Department of Planning and Zoning

TO: Design Advisory Board
FROM: Scott Gustin
DATE: July 24, 2018
RE: 18-1208CA/MA, 75 Briggs Street

Request: Construct new health club/climbing center. Includes a new building and related site improvements.

PHOTOMETRIC PLAN

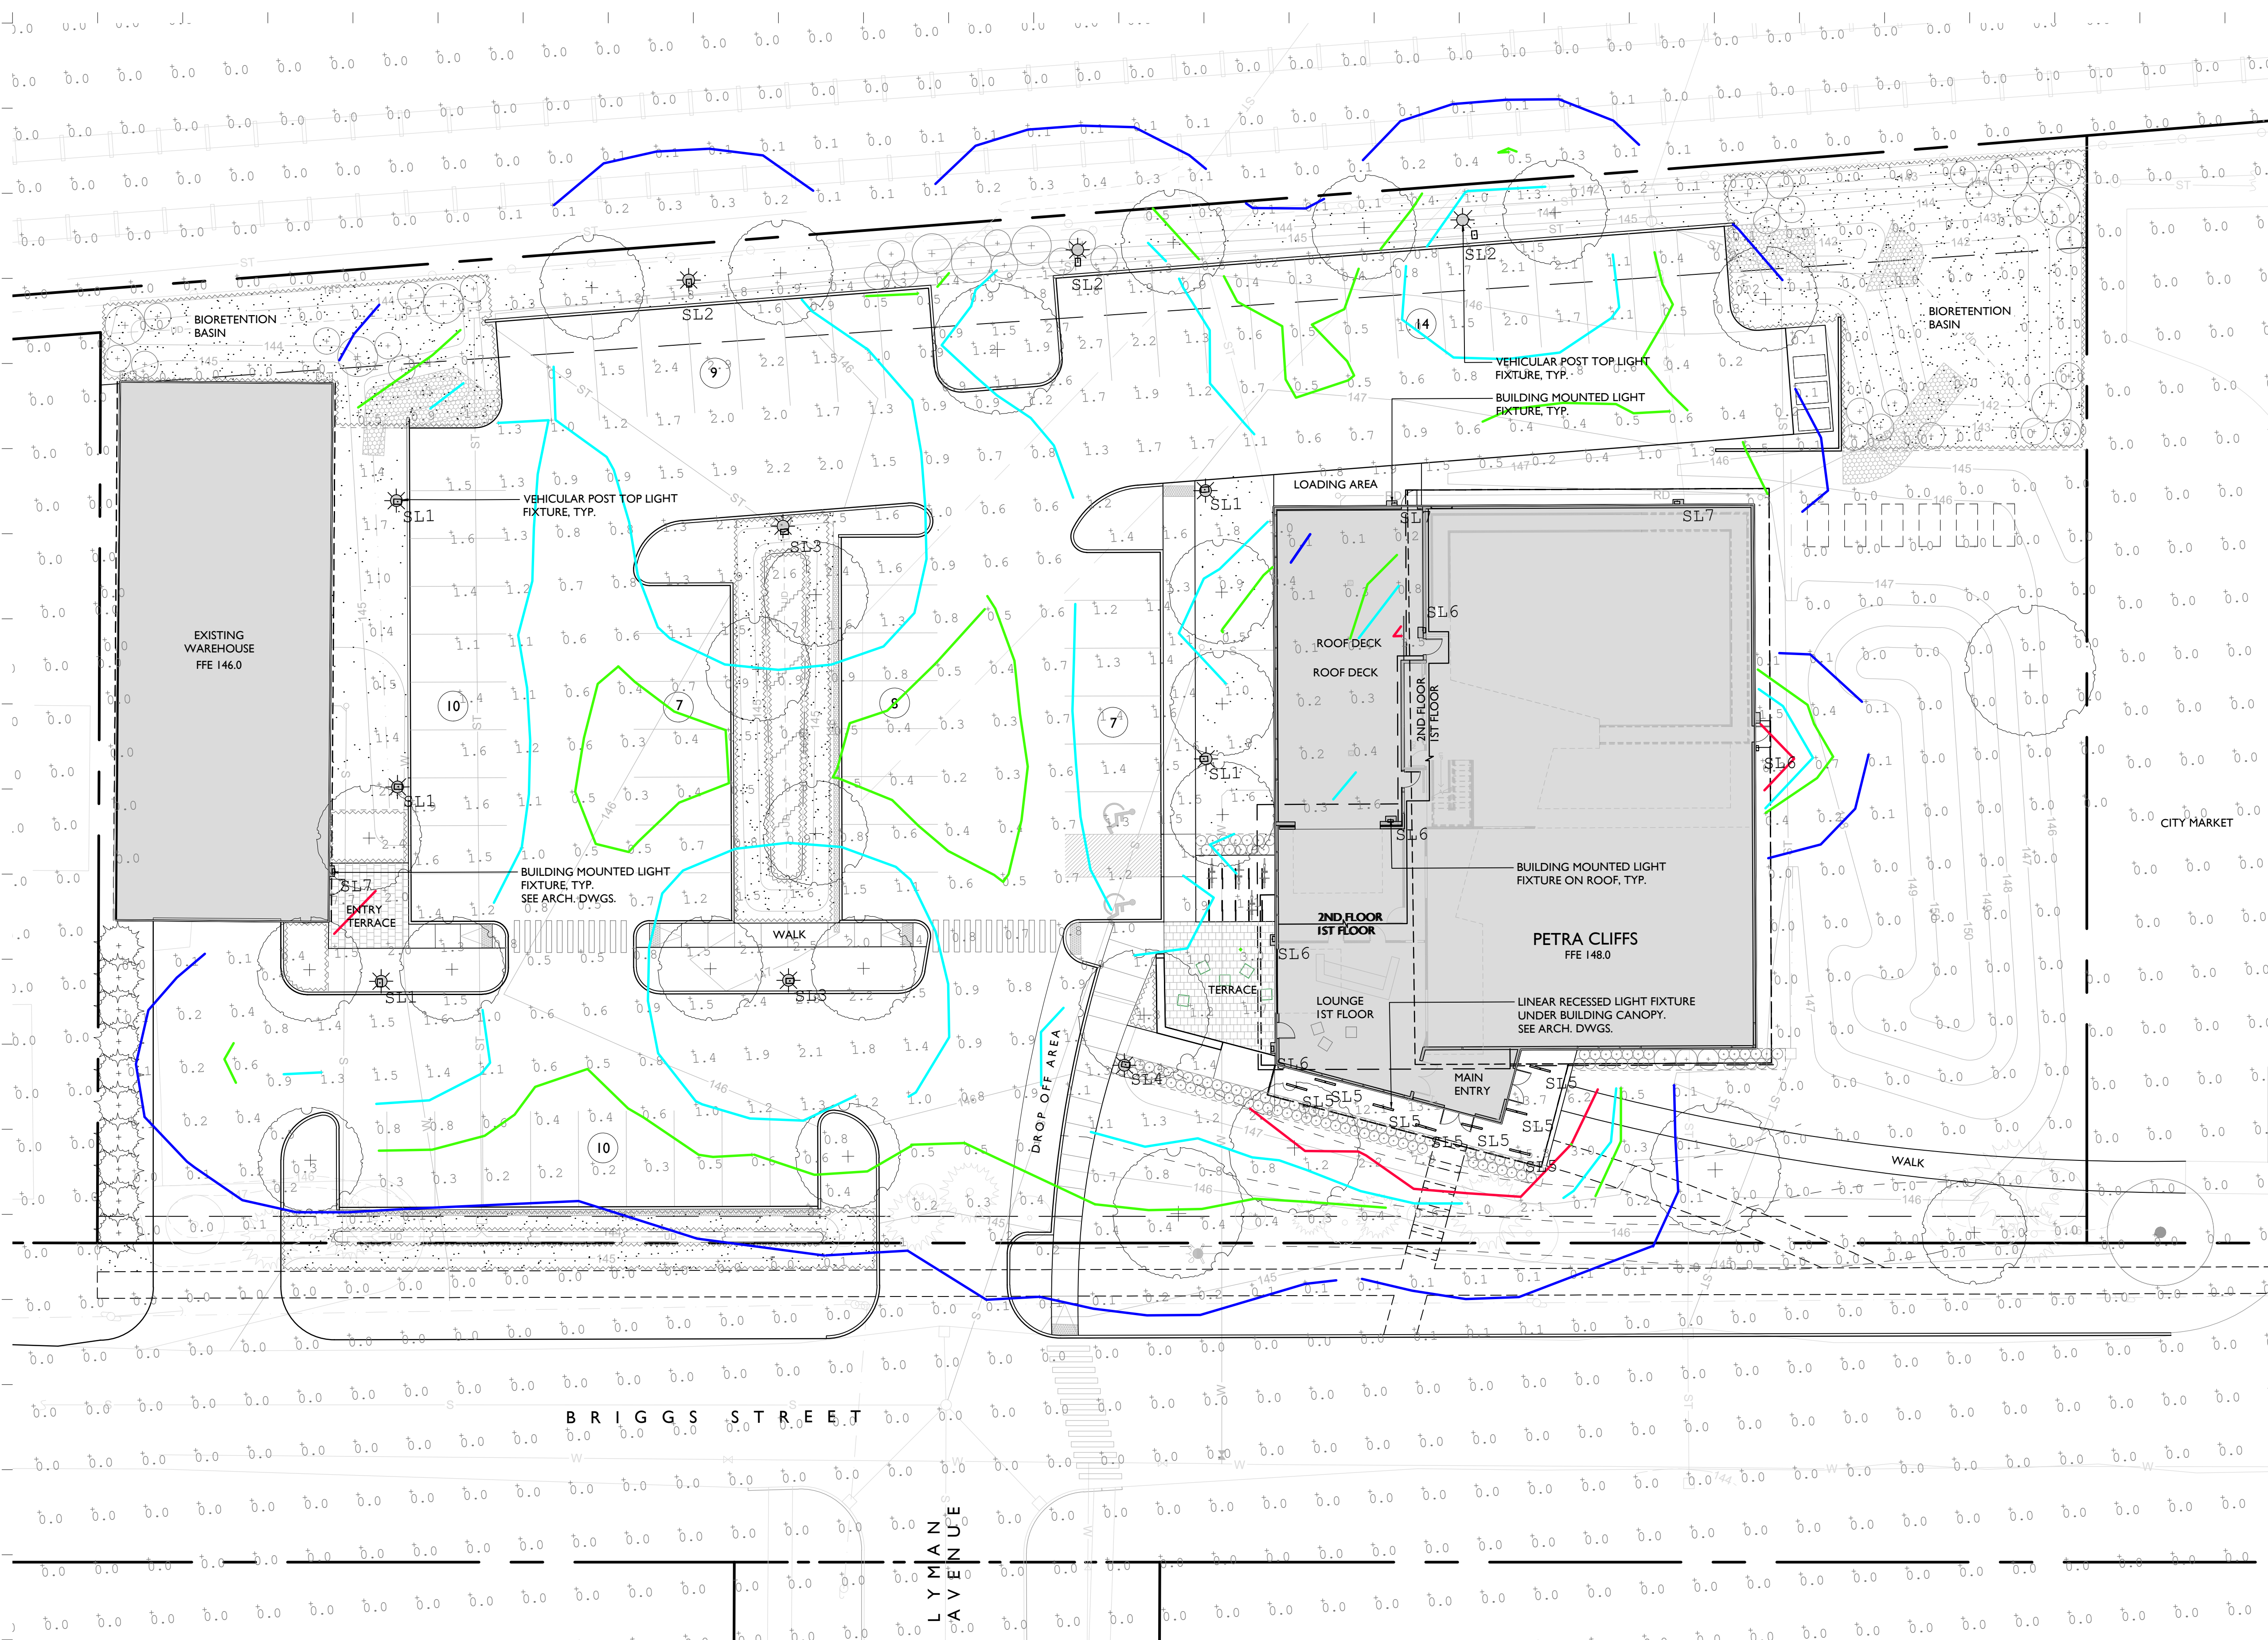
New outdoor lighting is included in the application and will include illumination of the parking area, walkways, and building entries. Fixture cut sheets and a photometric plan have been provided. Acceptable cutoff LED fixtures are proposed. Pole lamps illuminating the parking area are acceptable at 16' tall. Acceptable illumination levels are depicted for the parking lot and roof deck. While illumination levels are depicted for the building entries and walkways, the summary table does not indicate average, maximum, and minimum illumination levels for these features. This information is needed in order to determine compliance with the applicable lighting standards of Sec. 5.5.2. Building entries are limited to 5.0 footcandle average, and walkways are limited to 0.5 footcandle average with no point to exceed 2.0 footcandles.

5. The photometric plan shall be revised to include the maximum, minimum, and average illumination levels for the walkways and building entries, subject to the applicable standards in Sec. 5.5.2.
6. Location of electrical transformer box(es) shall be depicted and located behind the building or sufficiently screened. All utility lines shall be buried.
7. Installation of rooftop solar is encouraged.

1 BRIGGS STREET ELEVATION
1/8" = 1'-0"

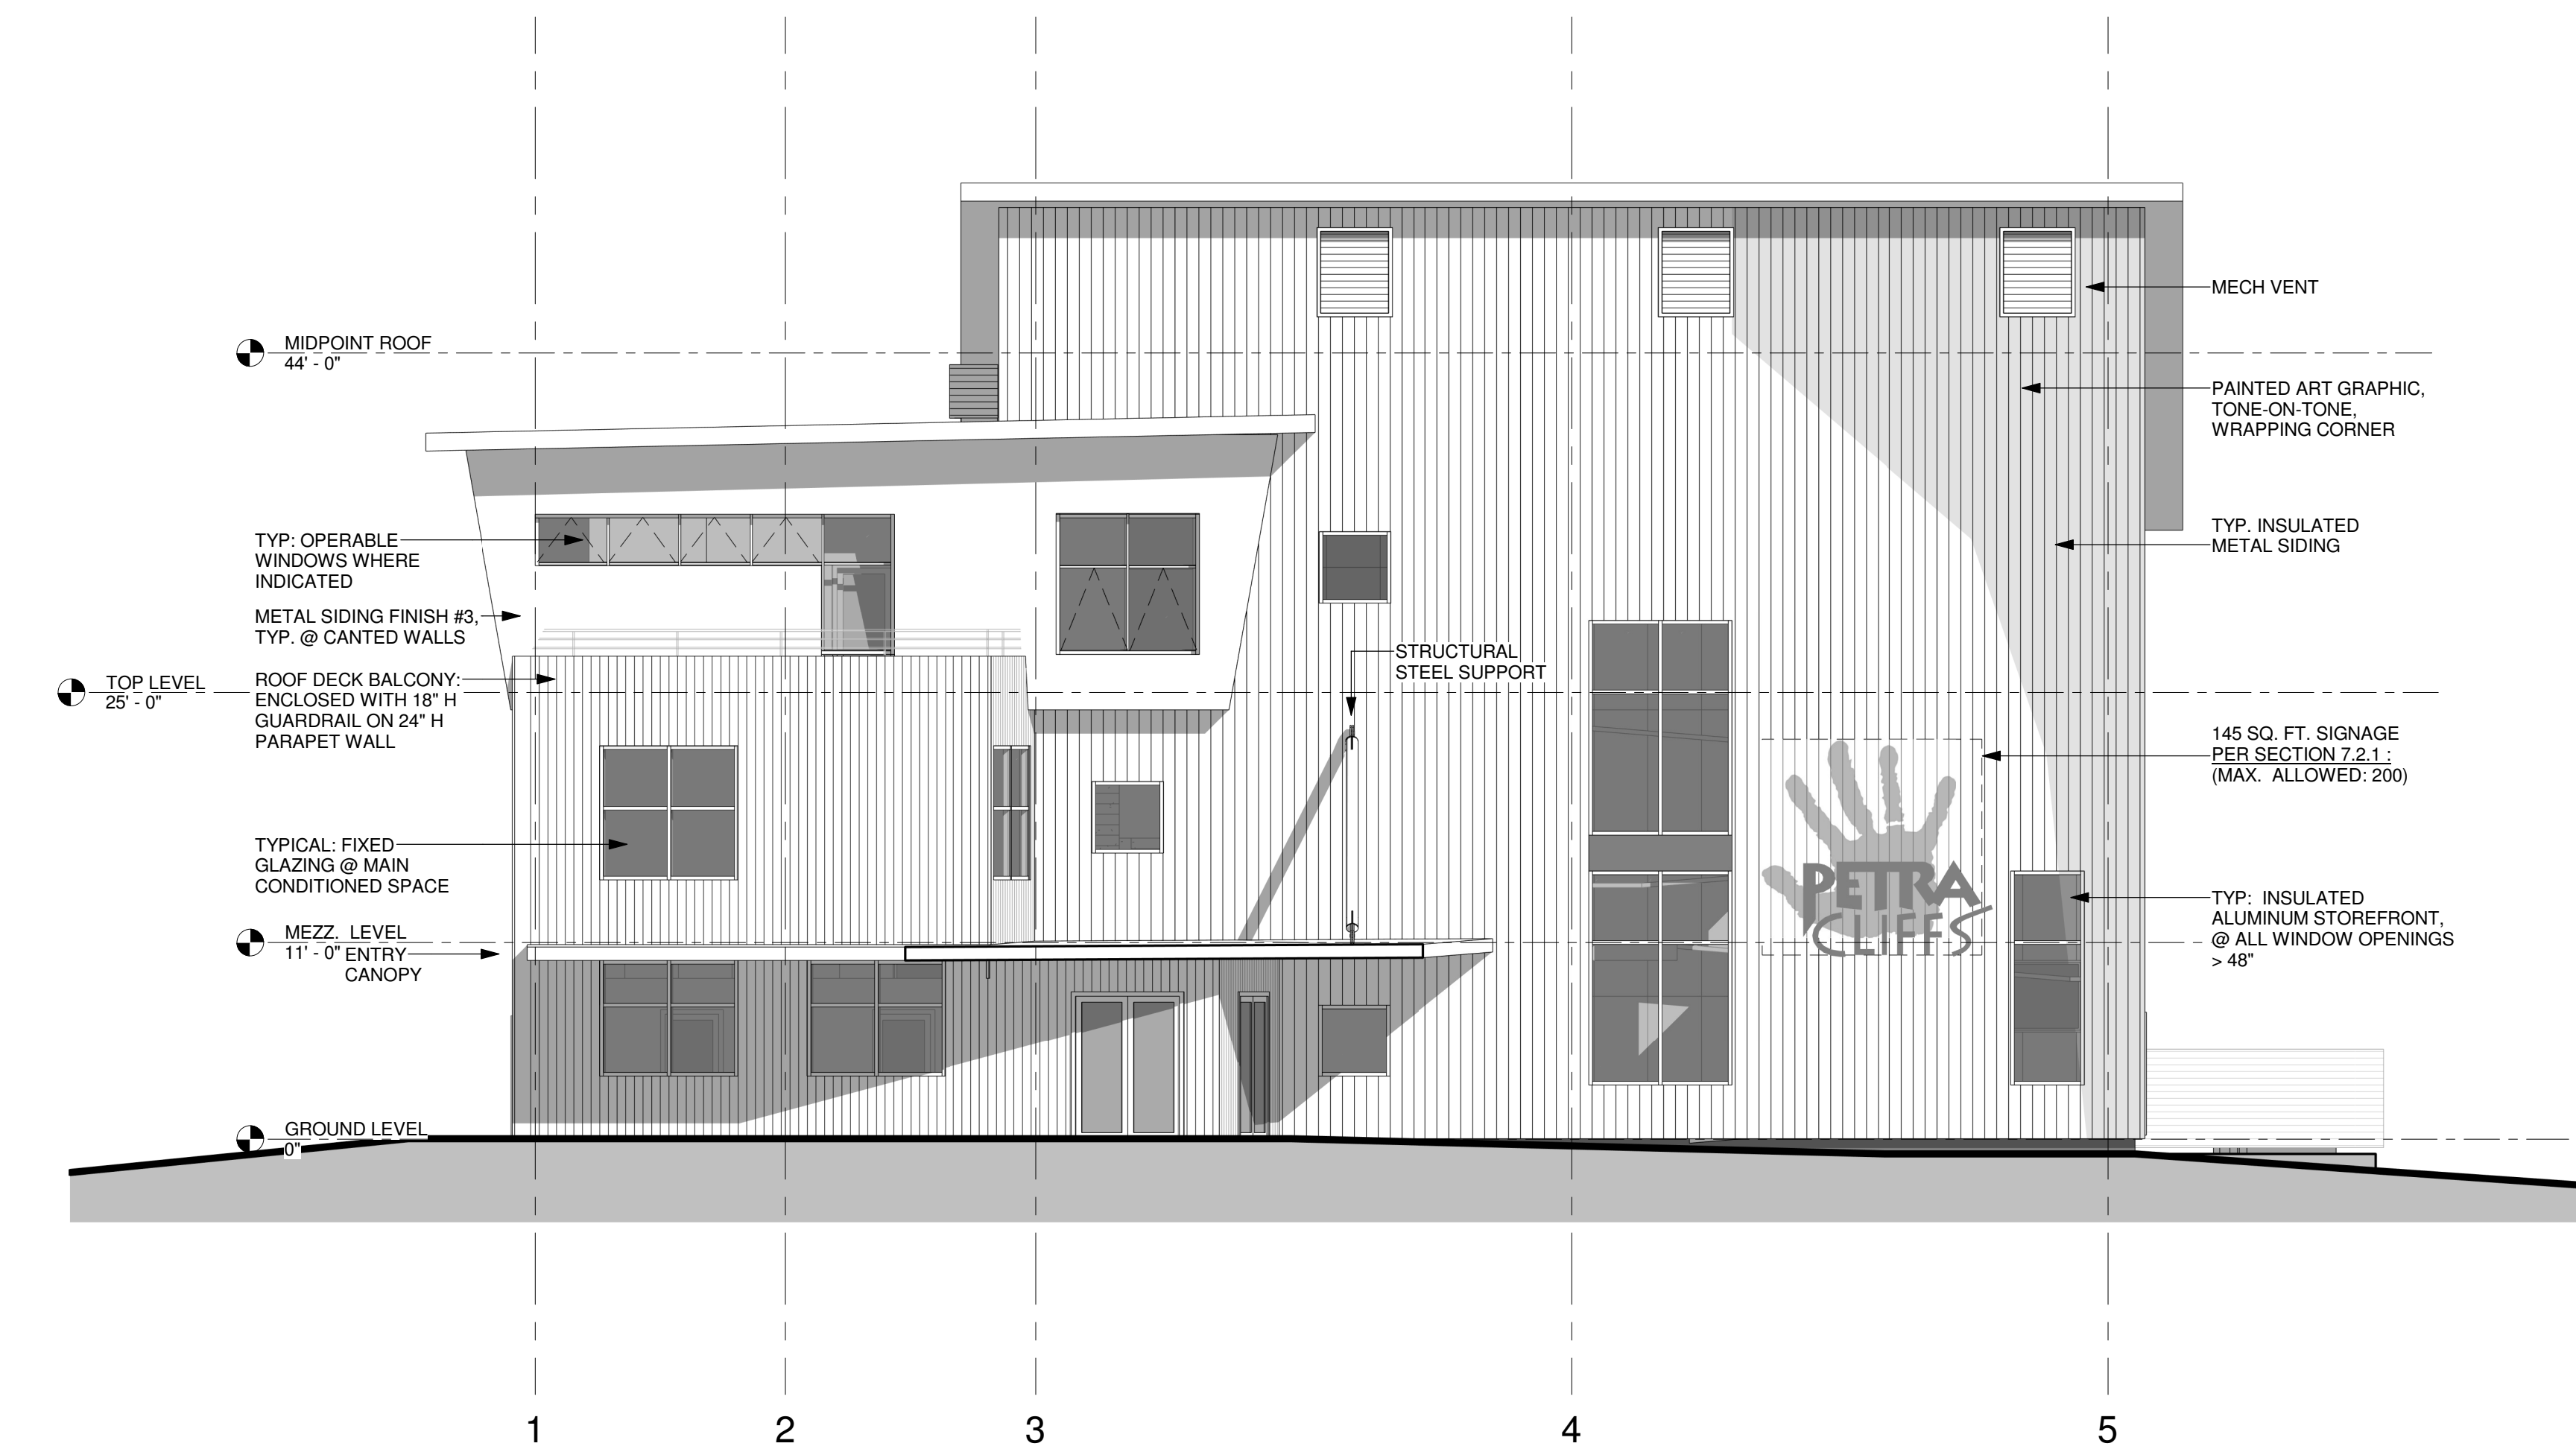
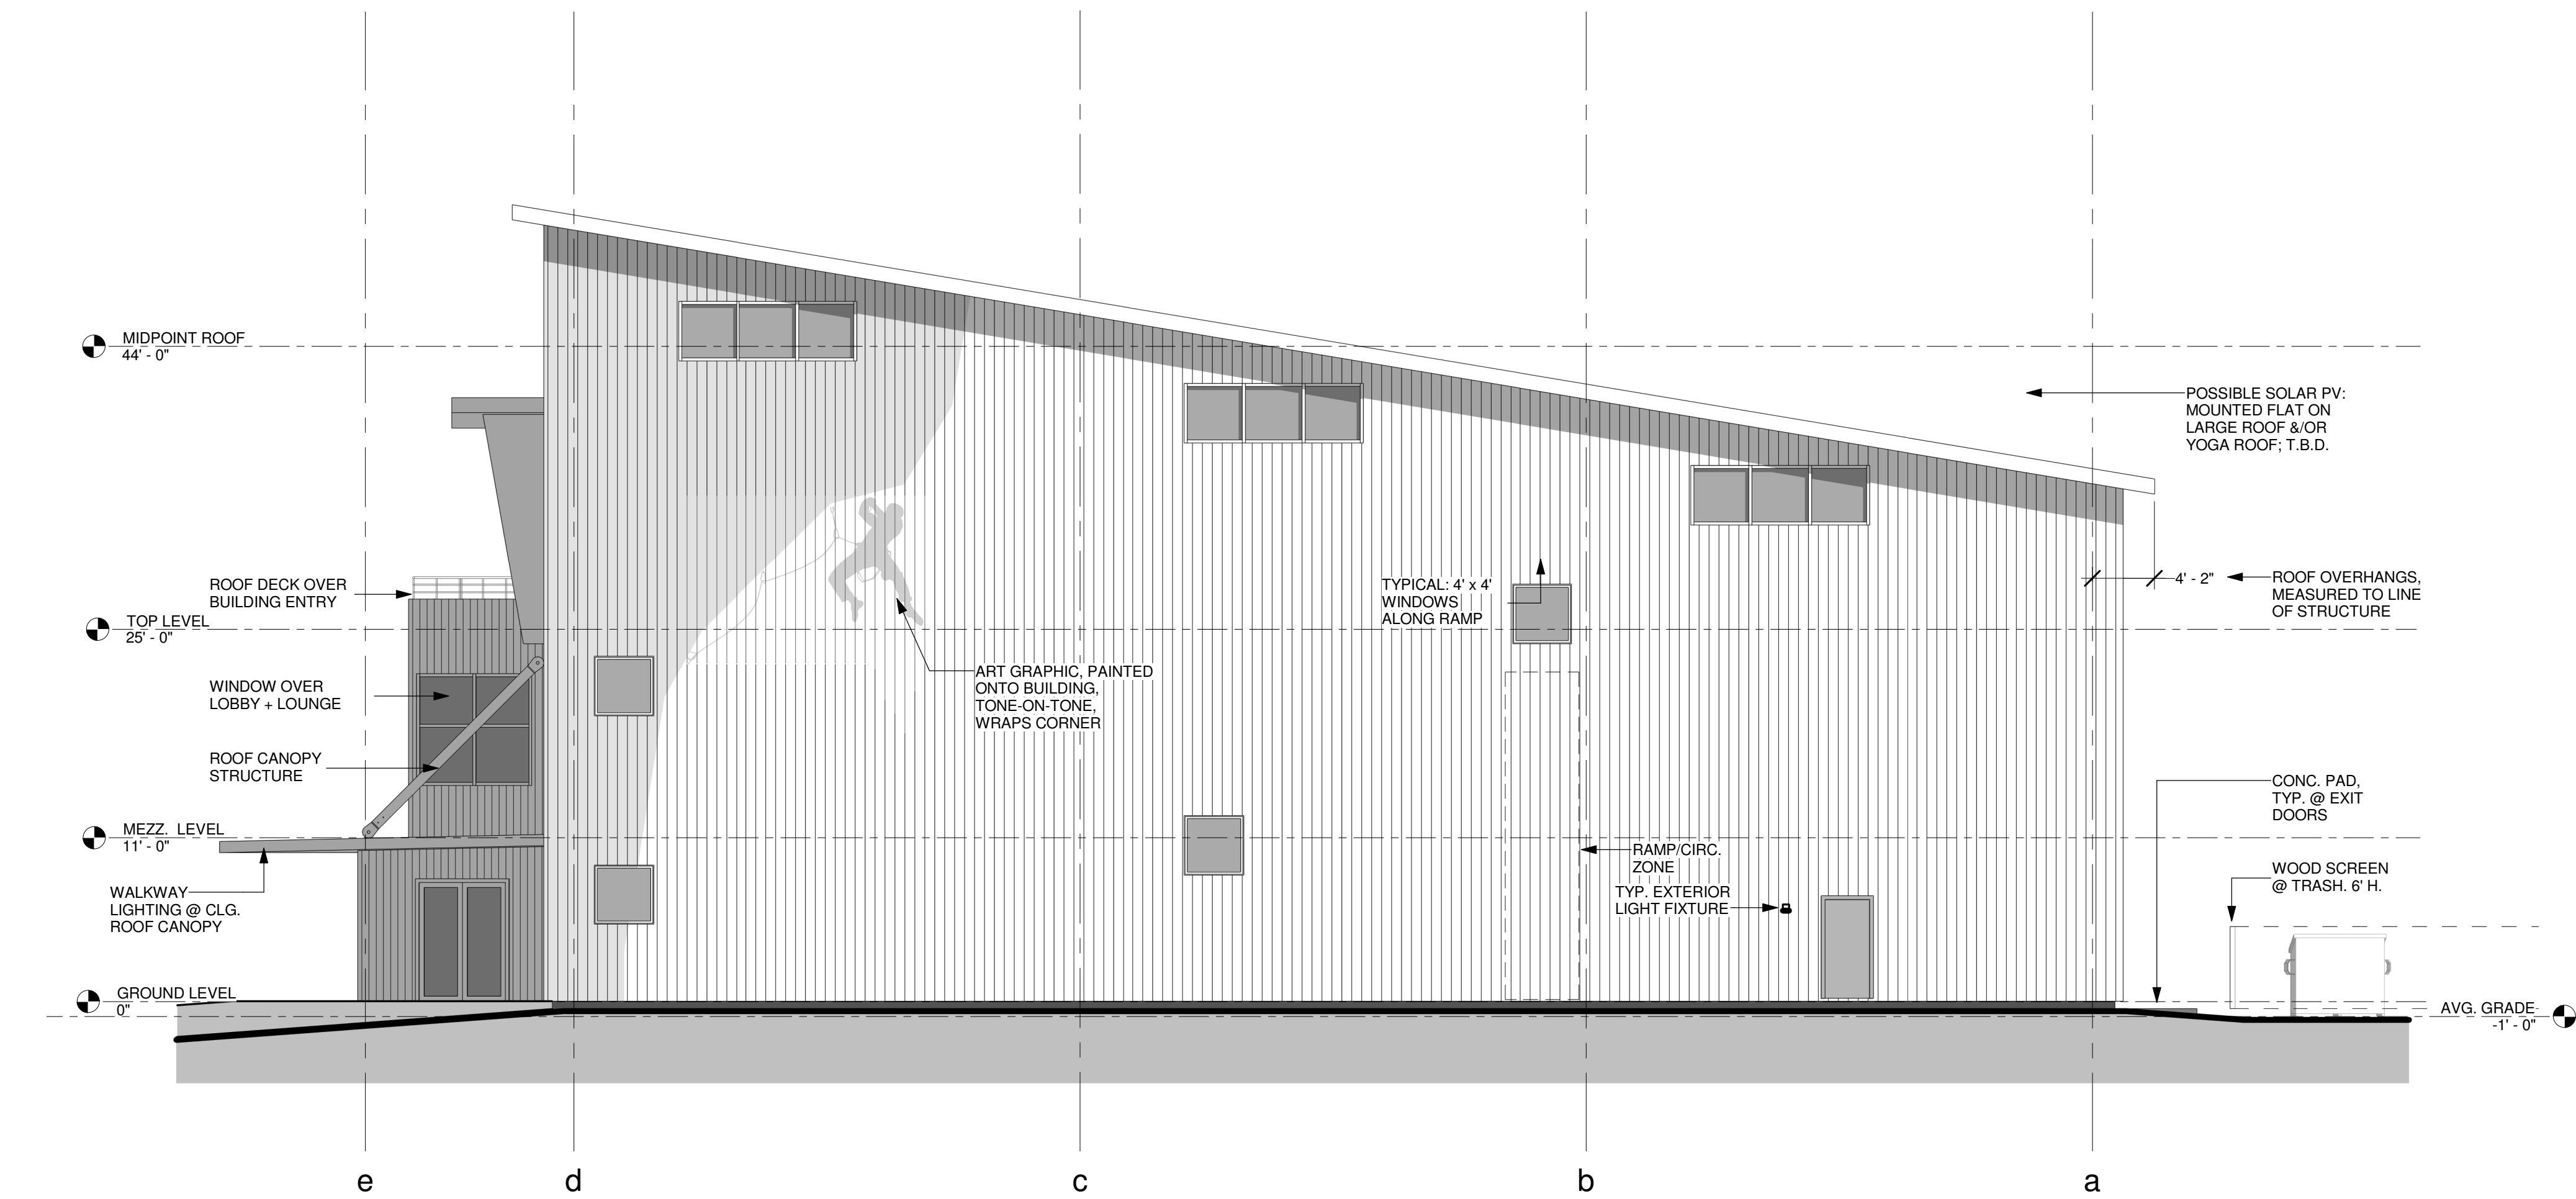
The primary building entrance is sheltered and oriented towards Briggs Street. It is also accessible from the parking area to the south. This primary entrance clearly reads as such. The fenestration is consistent with the angular, boxy appearance of the building. The function of the building's interior as a climbing center limits the placement and extent of fenestration. With that said, additional fenestration has been incorporated into the building's design since sketch plan review and is placed proportionately throughout.

Exterior signs are depicted on the elevation plans. Sign location and area appear to be acceptable. Exterior signage is handled by way of separate zoning permit in any event.
